Service Bulletin

Bulletin No.: 24-NA-047

Subject: Interior Indented Door Panel

Brand:	Model:	Model Year:		VIN:		Engine:	Transmission:
		from	to	from	to		
Cadillac	Escalade	2022	2024				
	Escalade ESV

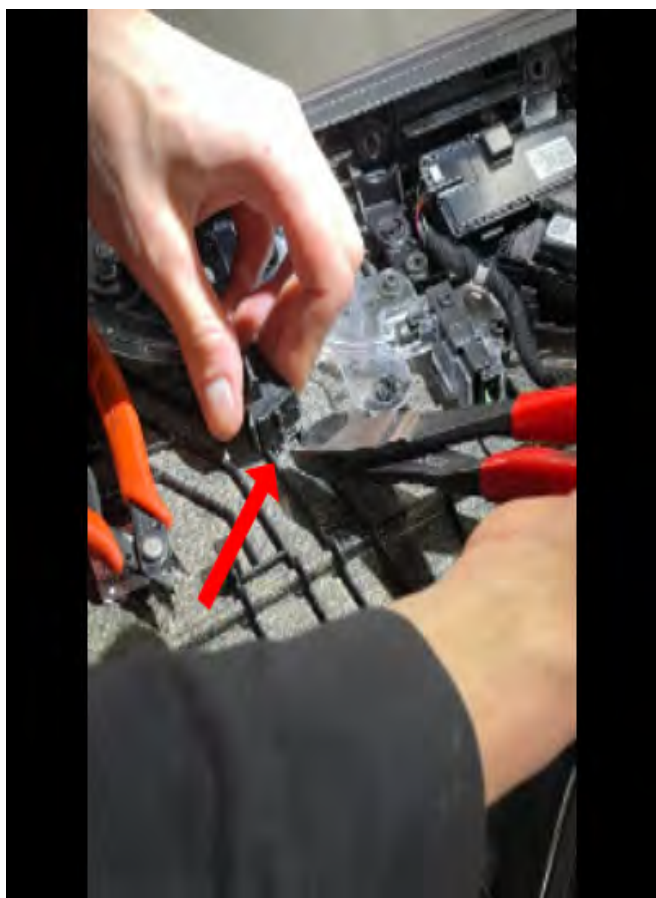
Involved Region or Country	North America, Europe, Kazakhstan, Russia, Middle East, Israel, Palestine, Japan, South Korea
Additional Options (RPOs)	
Condition	<p>Some customers may comment on one or both front interior door panels have become permanently indented at the forward/upper section of the door panel.</p>  <p style="text-align: right; font-size: small;">6570306</p>
Cause	The cause of the condition may be the edge material from the bezel/bolster has excessive contact pressure against the door panel retention clip when doors are closed.
Correction	<p>Replace the door panel and grind down the door panel retention clip.</p> <p>Important: Refer to the Electronic Parts Catalog (EPC) for the proper color door panel.</p>

- 2. Place the new door panel on a suitable table to remove the door retention clip.

3. Using a cutting tool cut off the door retention clip block.

Note: It's best to use a hand cutting tool and start at the center of the block then cut around the edges.

4. Then using a grind tool, smooth out the door panel.

1. Remove and replace the original door panel. Refer to *Front Side Door Trim Panel Replacement - Left Side in SI* and/or *Front Side Door Trim Panel Replacement - Right Side in SI*.

- Once the retention clip is smooth then replace the door panel.
